Subject: Duke Energy Carolinas, LLC
Oconee Nuclear Station, Units 1, 2 and 3
Docket Number 50-269, 50-270 and 50-287;
Response to Request for Additional Information Regarding License Amendment
Request to Change Technical Specification Surveillance Requirement
Frequencies to Support 24-Month Fuel Cycles
License Amendment Request (LAR) No. 2010-001, Supplement 3

Enclosure 1
Duke Energy Response to NRC Request for Additional Information (RAI)

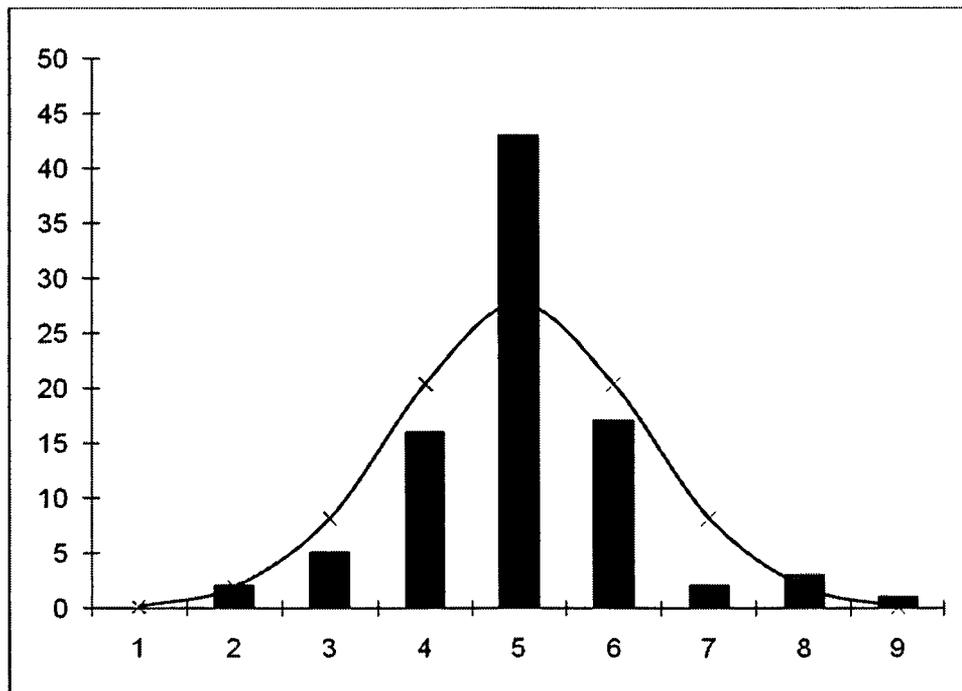
- c. Page 24: Please provide the definition and derivation of the normality adjustment factor (NAF) — including relevant source material and tables.

The normality adjustment factor is a multiplier whose magnitude is determined iteratively in order to increase the standard deviation of the sample data such that a minimum of 97.5% of the data is within the final tolerance interval established. This multiplier produces a normal distribution model for the drift, which shows adequate data population from the final data set within the $\pm 2\sigma$ bands of the model.

The term is an invented term based on the use of coverage analysis as discussed in EPRI TR-103335-RI, “Guidelines for Instrument Calibration Extension/Reduction Statistical Analysis of Instrument Calibration Data”, Final Report, October 1998 (Reference 8.1.2 of OSC-9719). The concept of coverage analysis is discussed in Section C.5 of the EPRI document and stems from the fact that instrument calibration data often has such a high kurtosis (i.e.; a high centered peak distribution) that the data will fail a normality test. The coverage analysis involves the use of a histogram of the data set, overlaid with the equivalent probability distribution curve for the normal distribution, based on the data sample's mean and standard deviation. Visual

examination of the plot is used, and the kurtosis is analyzed to determine if the distribution of the data is near normal. If the data is near normal, then a normal distribution model which adequately covers the set of drift data as observed is derived using the NAF. This normal distribution is then used as the model for the drift of the component or loop. Coverage analysis is discussed in detail in Section 4.8.3.3 of OSC-9719.

Instrument drift calculation OSC-9809 is an example where a NAF was applied to the drift data. Below is the histogram for this data set indicating the high kurtosis and near normal distribution of the data. This result is typical for those instrument loops where the final data set failed the normality test and therefore supports the use of coverage analysis as described in the EPRI document.
